Collimator Design Meetings

Minutes of the meeting 57 (03/02/2005)

Silver thickness measurement on RF contacts after 1500 cycles

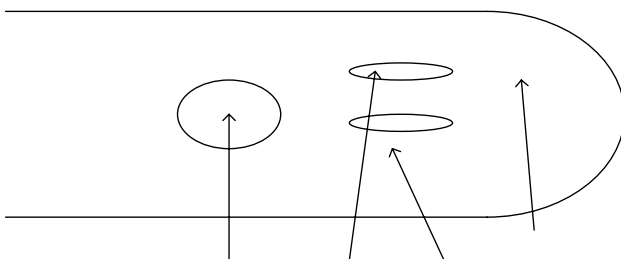
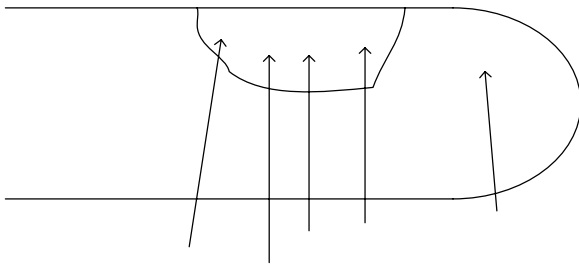
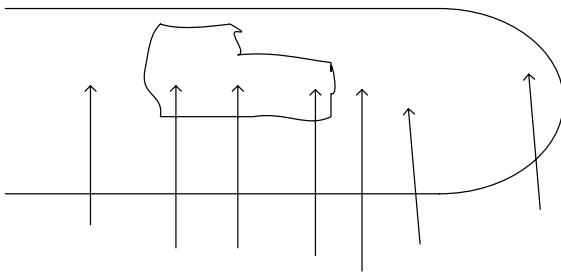
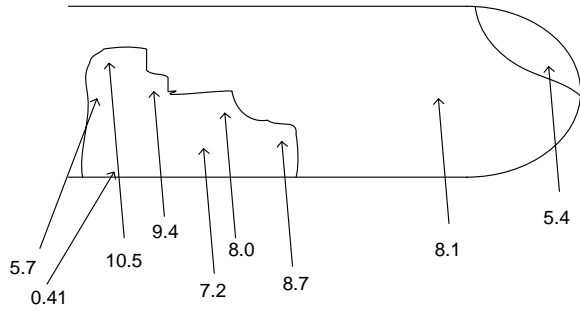
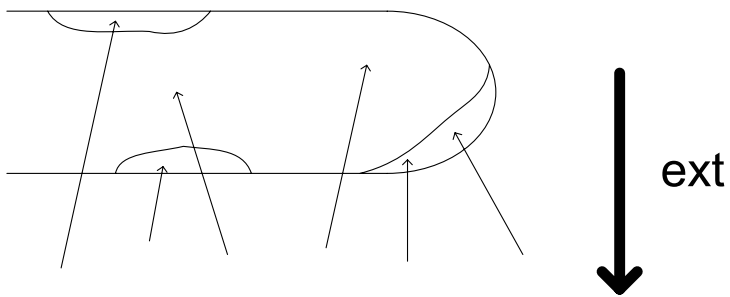
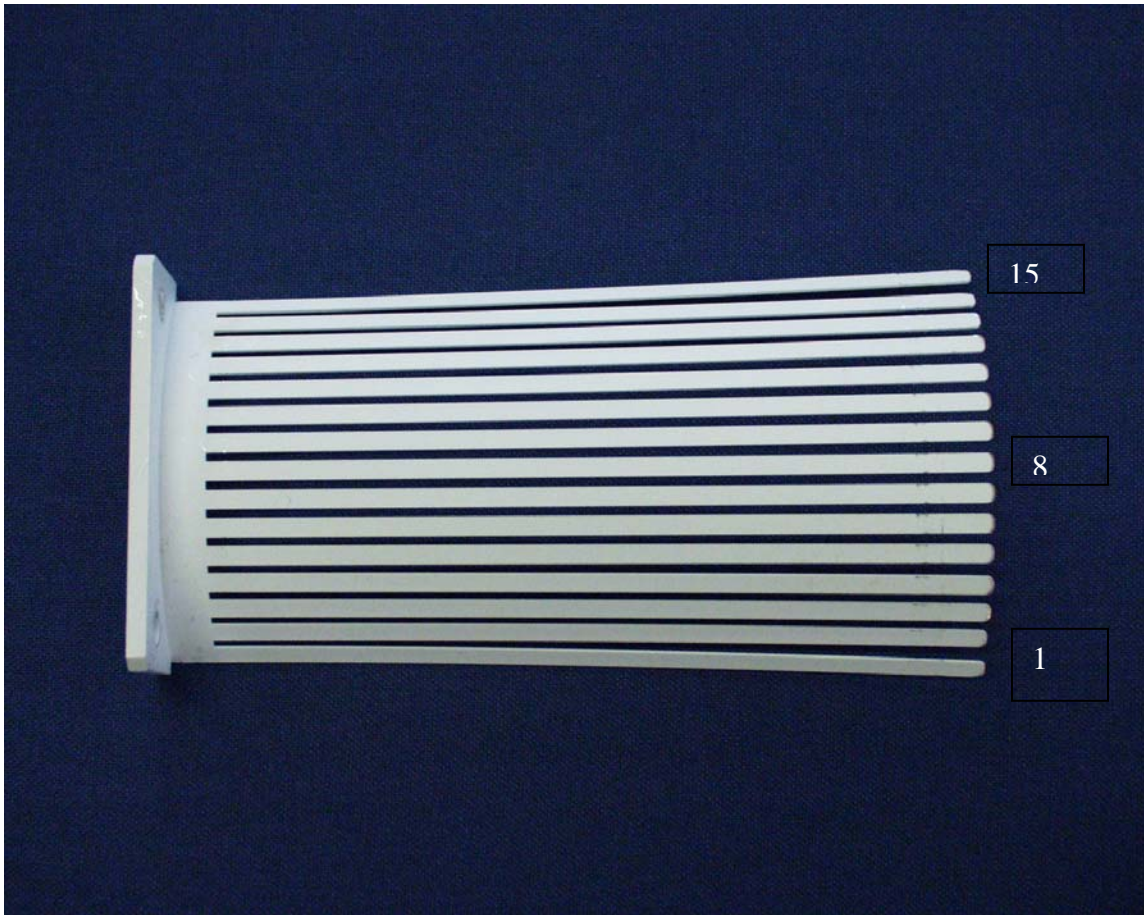
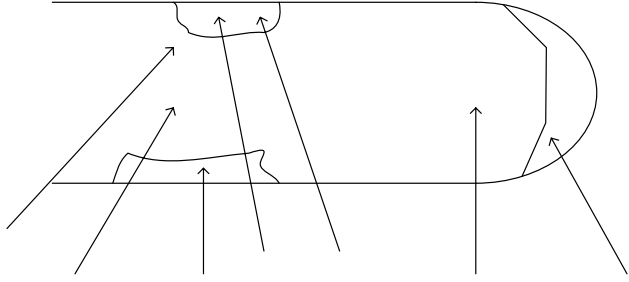
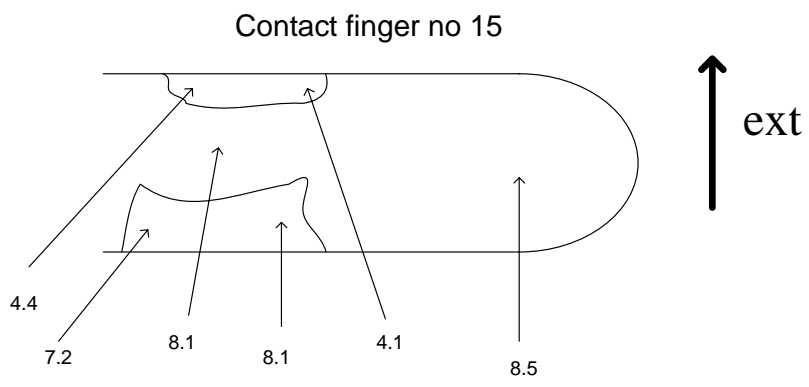
1. Sergio presented the measures executed on silver coated RF fingers after 1500 wear cycles against Rh plated flange: 8µm Ag coating is never completely eroded (see [AgThckMeasOnRFcont1500cyc.pdf](#)); nevertheless Sergio proposed to increase the coating to 20-30 µm.
2. To further decrease the contact bulk impedance, Sergio will check if the use of high-conductivity CuBe is viable.
